<b>MEETING:</b>	<b>PLANNING AND REGULATORY COMMITTEE</b>
<b>DATE:</b>	<b>4 SEPTEMBER 2024</b>
<b>TITLE OF REPORT:</b>	<p><b>232851 - PROPOSED RESTORATION AND RESIDENTIAL USE OF THE FARMSTEAD AT AUBREYS INCLUDING: THE CONVERSION OF AND EXTENSION OF THE EXISTING FARMSTEAD, PROPOSED DETACHED BUILDING FOR GARAGING, WORKSHOP AND PLANT STORAGE, EXTENSIVE LANDSCAPING AND REWILDING OF THE WIDER SITE, THE INSTALLATION OF AN ACCESS TRACK AND ASSOCIATED WORKS AT AUBREYS, TO THE WEST OF THE MOUNTAIN ROAD, LLANVEYNOE, LONGTOWN, HR2 0NL</b></p> <p><b>For: Ms Gardner per Mr Matt Tompkins, Lane Cottage, Burghill, Hereford, Herefordshire HR4 7RL</b></p>
<b>WEBSITE LINK:</b>	<a href="https://www.herefordshire.gov.uk/info/200142/planning_services/planning_application_search/details?id=232851">https://www.herefordshire.gov.uk/info/200142/planning_services/planning_application_search/details?id=232851</a>
<b>Reason Application submitted to Committee – Redirection</b>

**Date Received: 26 September 2023**      **Ward: Golden Valley South**      **Grid Ref: 327439,233041**  
**Expiry Date: 23 November 2023**  
Local Members: Cllr Matthew Engel

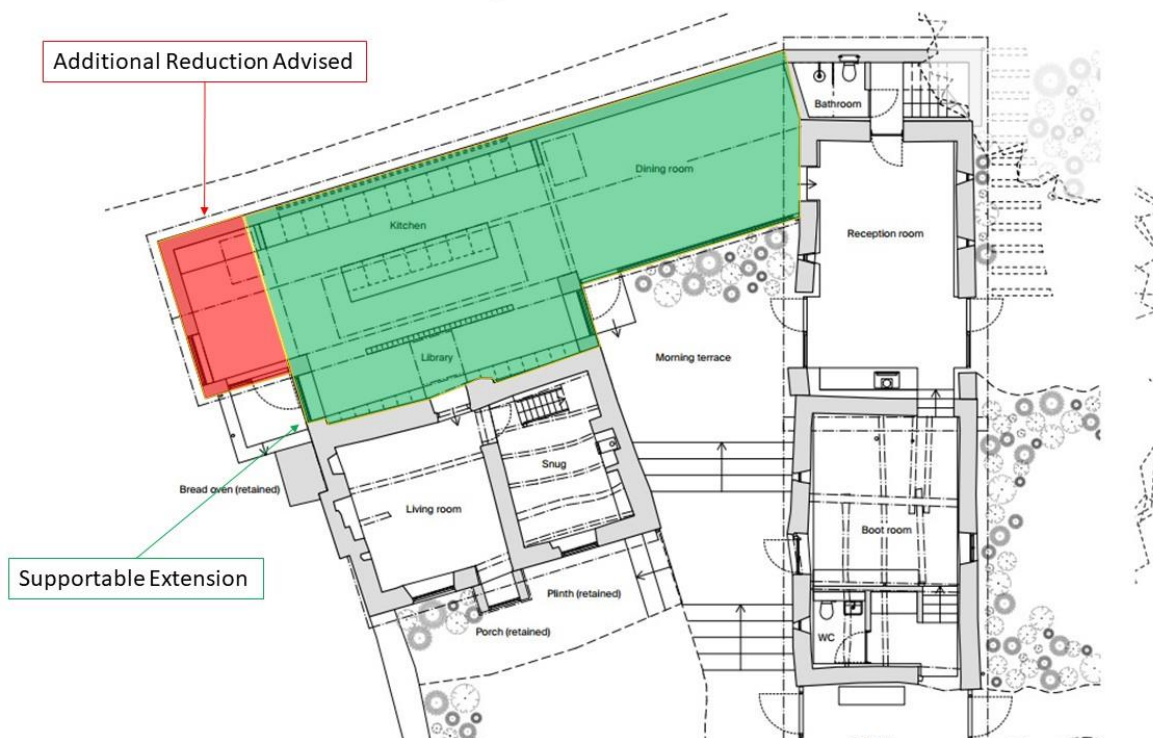
As highlighted in January and November 2023, no structural report has been submitted to support either application, and so whilst the general principles of the conversion/extension design and associated access works can be broadly understood, it is not possible to determine whether the scheme can actually be executed within relevant policy parameters without this level of assessment being provided from the outset.

A report of this nature should also set out in detail all of the structural works necessary to achieve the finished conversion scheme as it is proposed, particularly as the scale of works necessary to introduce the rearward extension, and create the stepped access between the farmhouse and farm buildings, is such that these historic structures could be catastrophically undermined and compromised, with any re-building likely to result in loss of distinctive character and patination.

### Proposed Threshing Barn:

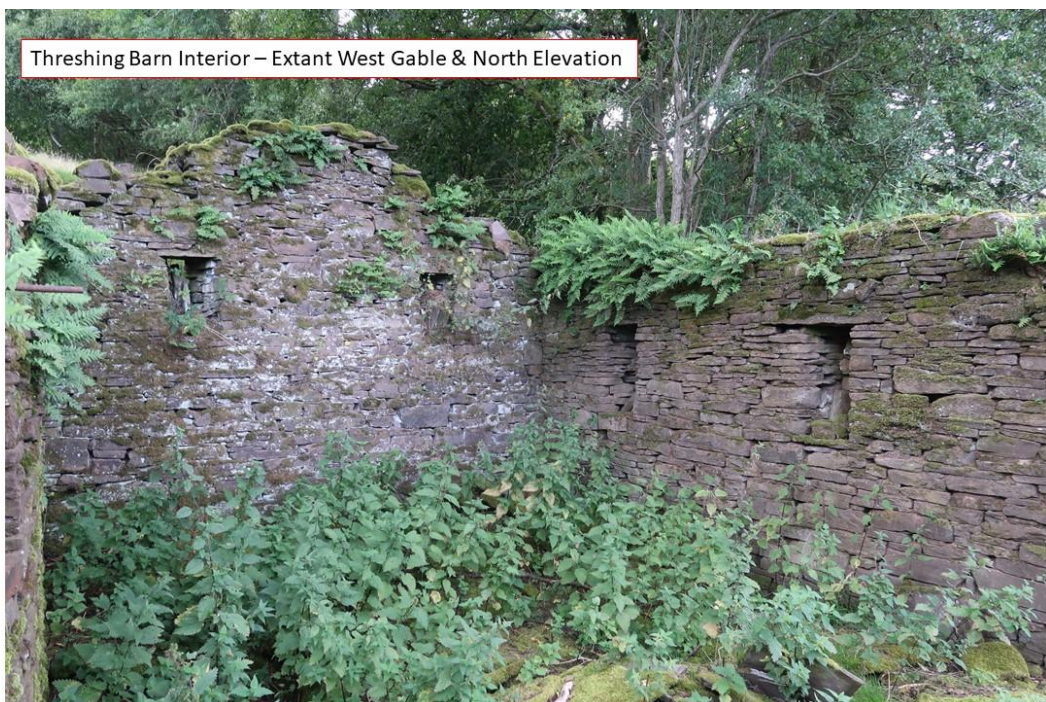
No amendment to this barn's proposed extension has been presented, and so it remains that the increase in its height and length necessary to accommodate a 1<sup>st</sup> floor level and an access staircase/WC at its western end would be contrary to what the evidential remains of its fabric indicate was its original form or function (LD4), and would represent substantial extension (RA5) given it would increase the functional footprint from c.35m<sup>2</sup> to c.78m<sup>2</sup>, an increase of over 100% on a non-domestic building.

Retention of its historic form, as supported by the evidence, would require a further c.0.5m reduction in height at wall plate level (see images below from 2019), and utilisation of matching stone for the re-introduced of wall tops is reflective of previous advice.

As can be seen from the above images there is no evidence of any former loft level in this building, and the pattern of stone loss from the walls is entirely consistent with a form which only requires minimal consolidation to replicate, with both gables - excepting their apexes - and the flanking walls remaining near enough at their historic heights – which is also consistent with a barn size/form which could support the subsistence scale of this particular smallholding.

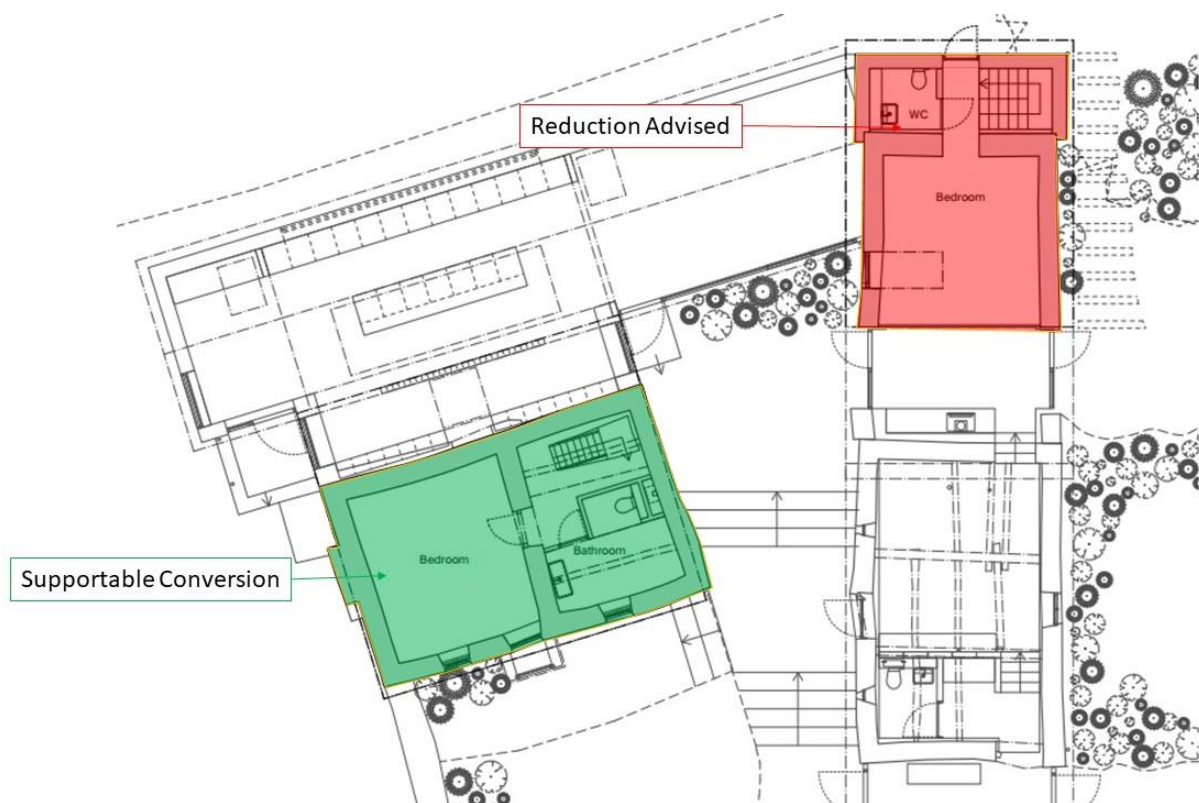
Whilst many threshing barns can differ somewhat in their scale, form and features for a variety of geographic/economic/technological/functional reasons this one appears very specific to its context, and so introducing unevidenced changes, such as staircases, lofts and pitch holes, simply to meet certain domestic needs detrimentally dilutes its significance, distorts its integrity and special interest, and confuses understanding of its historic character and contribution to the wider group; this approach represents renovation rather than sympathetic conservation.

Consequently, conversion which maintains the historic single-storey structural form remains the advocated approach, and so, as proposed, it is considered a cumulatively harmful extension.
